**GOVERNMENT OF THE DISTRICT OF COLUMBIA  
DEPARTMENT OF CONSUMER AND REGULATORY AFFAIRS  
OFFICE OF THE ZONING ADMINISTRATOR**

RE: Construction of Single Family Dwelling at 3270 Prospect St NW

JOB WOODILL  
CARRIAGE HOUSE

**A100**

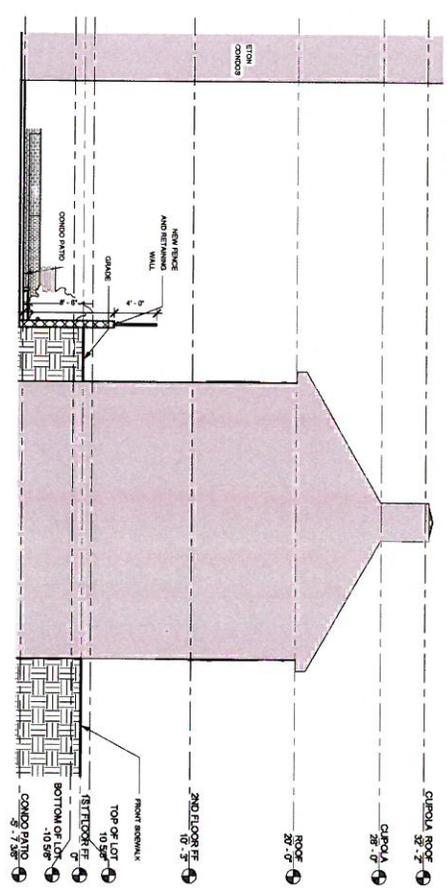
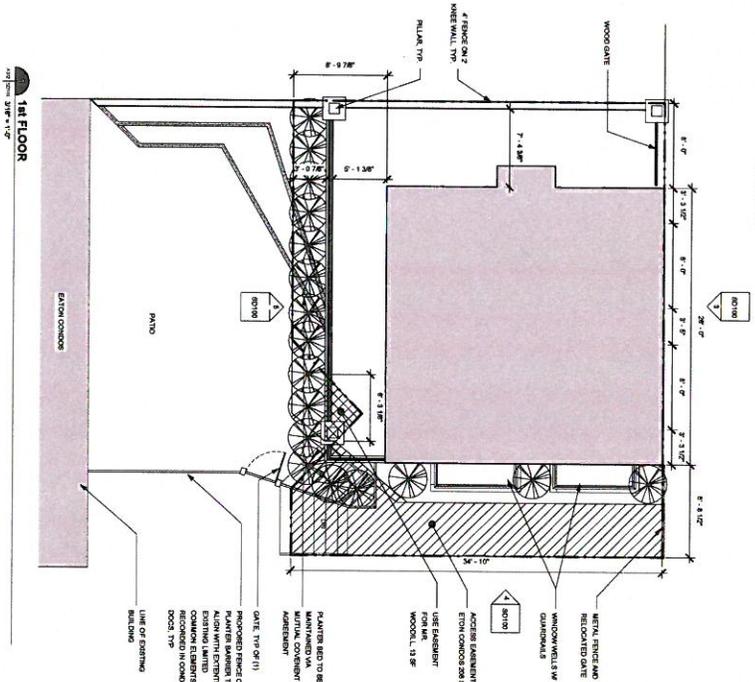
The proposed Project, consists of two stories above grade, sitting on a cellar level, this is permissible, provided the total Building Height is less than forty feet (40) per 11 DCMR §§ 400.1 and §§400.15 – 400.22. Due to your lowest level having a ceiling height that is less than that of the adjacent grade, the lowest level is compliant with the definition of Cellar, as per 11 DCMR §§ 199. The proposed window wells, which are exclusively for egress purposes and do not project more than five (5)’ perpendicular from the face of the building do not affect the classification of the lowest level as a cellar. Lastly, per 11 DCMR §§ 400.3, your proposed cupola is exempt from height requirements or calculations.

You propose to provide 8' side yards. Utilizing the building height calculation, as prescribed in 11 DCMR §§ 400.18 (a), both side yards proposed are compliant with the width rules for height, as prescribed in 11 DCMR §§ 405.
